Heathridge Park

HEATHRIDGE PARK MASTERPLAN - CONCEPT DESIGN - OPTION 2

Proposed concept design amendments – Heathridge Park masterplan

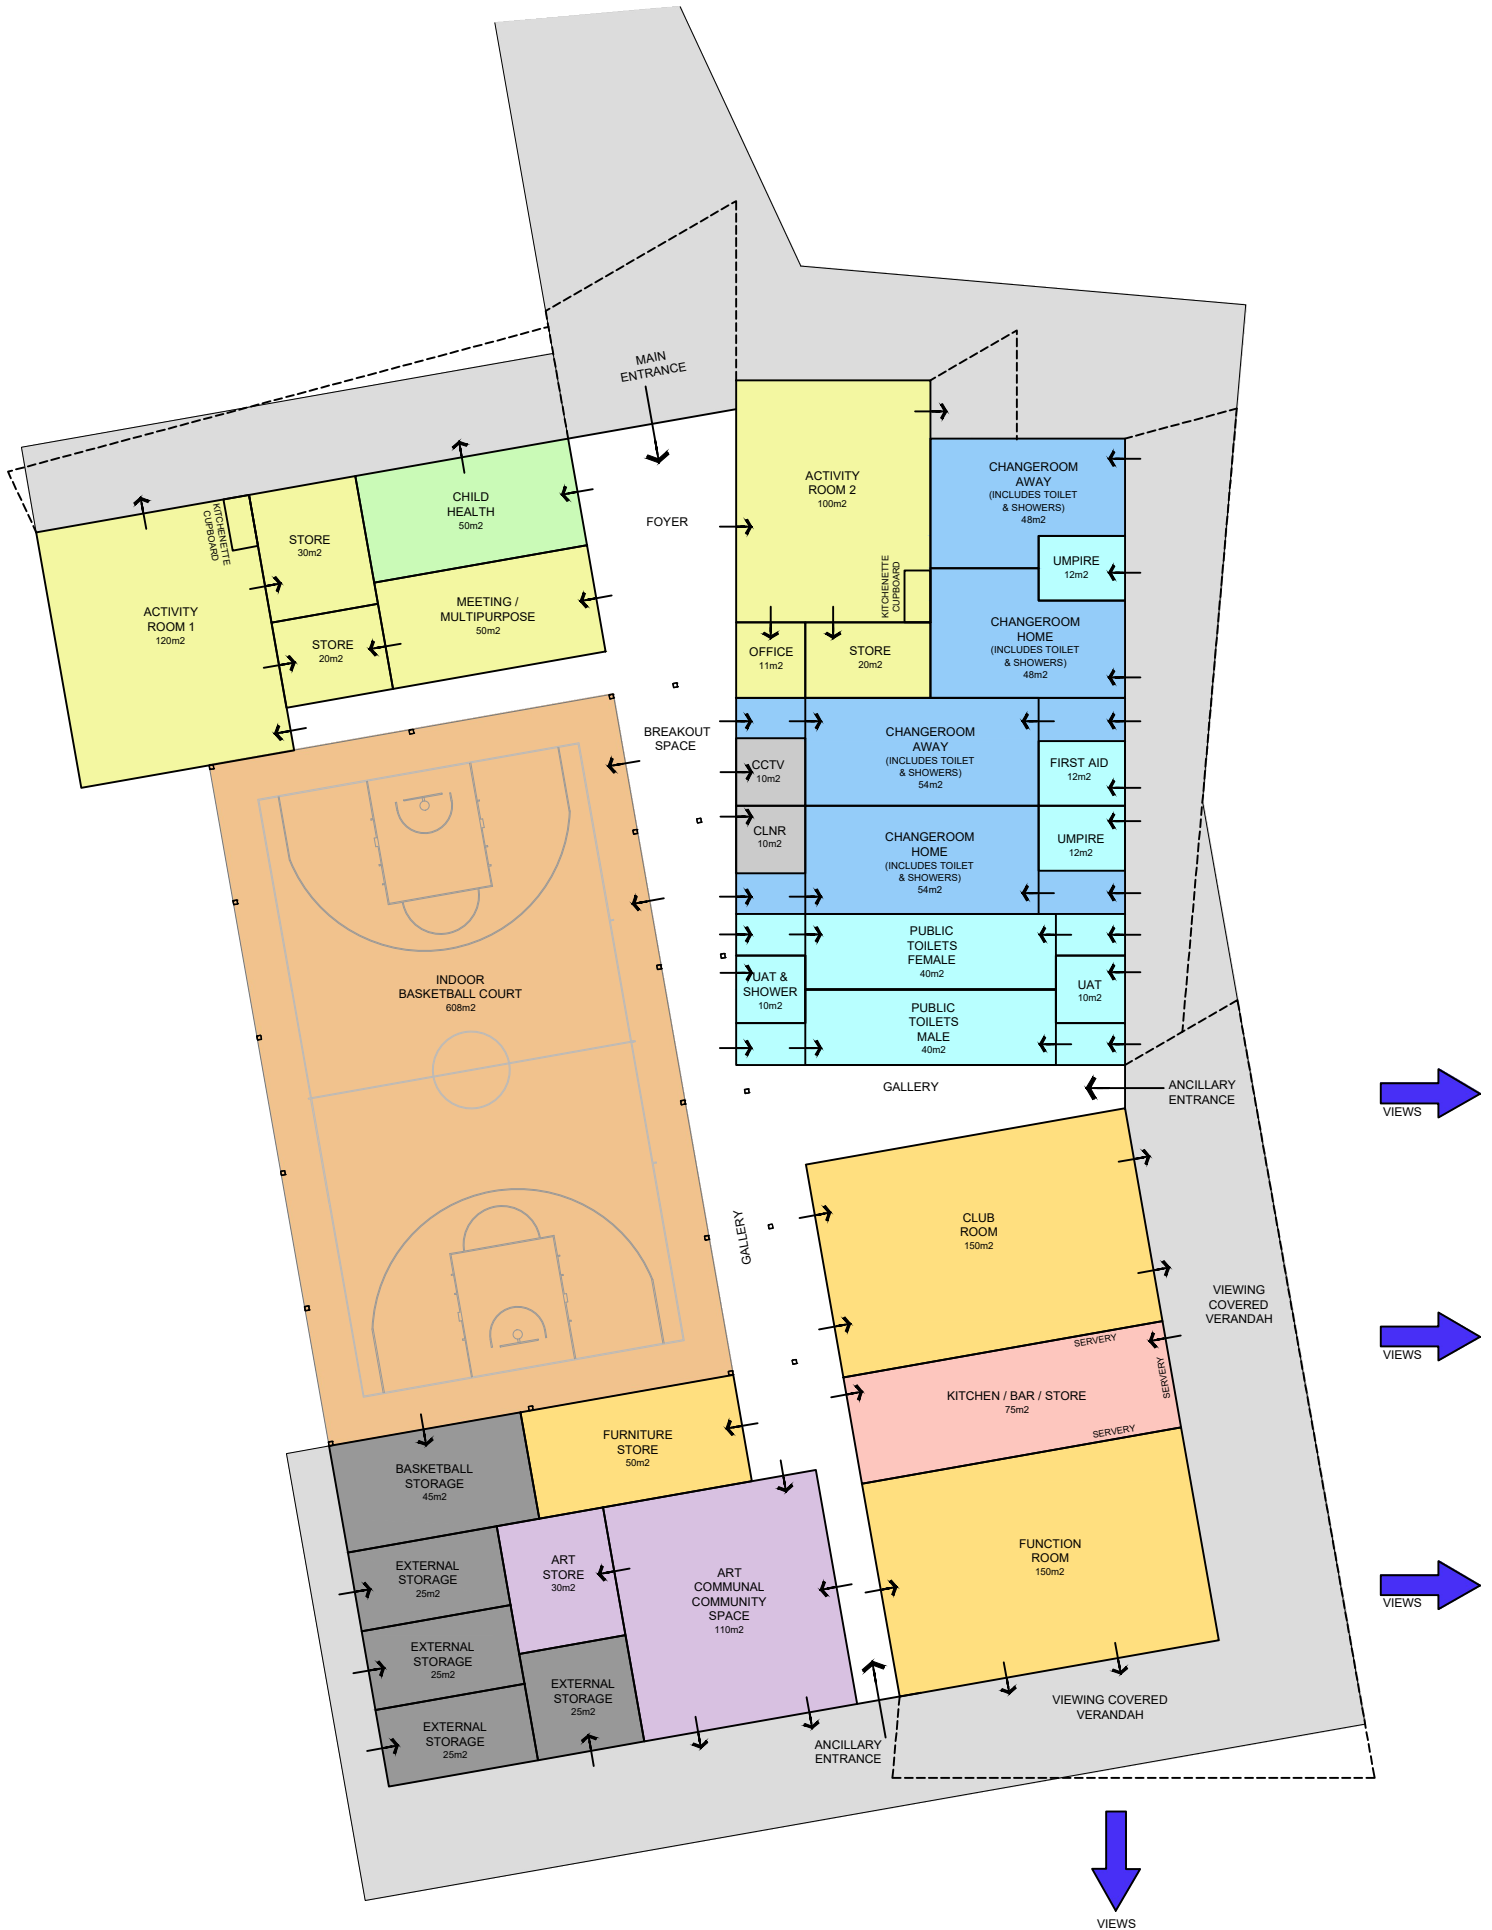
Component	Included in previous concept designs	Proposed amendments	Comment
Car parking (item 1 / 18 on concept design)	No additional car parking included.	Additional car parking to be included.	There is insufficient car parking around the park. Currently, on games days for the sporting clubs, the existing car parks are at capacity. Additional parking is to be included near the proposed new building and in the area where the existing Heathridge Community Centre is located. Vehicle access between car parks is also to be considered.
Building design (item 2 / 3 on concept design)	Limited number of rooms included in the design.	Additional rooms added to the design.	The review of bookings data identified that additional spaces are required due to an increase in usage by community groups. Additional spaces are also required for user group storage due to the increase in usage, and to meet the City's standard provision for community and sporting facilities. A review of the City's standard provision identified that additional features were required.

Second AFL oval (item 4 / 5 on concept design)	Expansion of sports playing field area to accommodate a second AFL oval.	Sports playing field not to be expanded. Sports floodlighting to be retained in existing locations.	Expansion of the sports playing field to accommodate a second AFL oval would require: <ul style="list-style-type: none"> • Relocation of the existing drainage site which would result in additional costs. • The removal of mature trees. • An upgrade of the sports floodlighting which would result in additional costs.
Tennis courts (item 6 on concept design)	Six new tennis courts included.	Eight tennis courts included.	The Ocean Ridge Tennis Club has advised that six courts are not sufficient for existing and future operations. Tennis West have indicated that eight courts are required to host inter-club competitions. The community consultation undertaken in late 2020 indicated that 37.5% of respondents supported or strongly supported the reduced number of courts, and 37.5% of respondents opposed or strongly opposed the reduced number of courts. A further 19.4% of respondents indicated that they were neutral (the remaining 5.6% of respondents did not provide a response to this question).

Basketball pad (item 7 on concept design)	Basketball pad close to the new building.	Basketball pad relocated to alternate location.	The half court basketball pad is proposed to be located approximately 60 metres from residents on the previous concept design. The draft Department of Water and Environmental Regulation (DWER) guidelines will require outdoor basketball courts to be located at least 90 metres from residents to help minimise the impact of noise on residents, so the basketball pad will be relocated accordingly.

Component	Included in previous concept designs	Proposed amendments	Comment
Cricket nets (item 8 on concept design)	Four new cricket nets included.	Existing cricket nets to be retained. New lighting to be provided.	The relocation of the cricket nets was required to accommodate a second AFL oval. The removal of these works means that the existing cricket nets can be retained and upgraded with new lighting. The community consultation undertaken in late 2020 indicated that 53.7% of respondents supported or strongly supported the relocated cricket nets, and 6% of respondents opposed or strongly opposed the relocated cricket nets. A further 31.9% of respondents indicated that they were neutral (the remaining 8.4% of respondents did not provide a response to this question).
Informal amphitheatre / event space (item 11 on concept design)	Terraced seating and informal stage included.	Design of informal amphitheatre / event space to be scaled back.	There is no requirement for a stage / amphitheatre in this area as the park is already utilised for outdoor events and will provide sufficient event space in the future, if required. The proposed location is in close proximity to residents and may create noise issues. It is proposed to scale back the design of the amphitheatre / event space. The community consultation undertaken in late 2020 indicated that 56.9% of respondents supported or strongly supported the informal amphitheatre / event space, and 11.1% of respondents opposed or strongly opposed the informal amphitheatre / event space. A further 23.6% of respondents indicated that they were neutral (the remaining 8.4% of respondents did not provide a response to this question).

Drainage site (item 14 / 15 on concept design)	New drainage included.	Retention of the existing drainage site.	The relocation of the existing drainage was required to accommodate a second AFL oval. The removal of these works means that the existing drainage area can be retained.
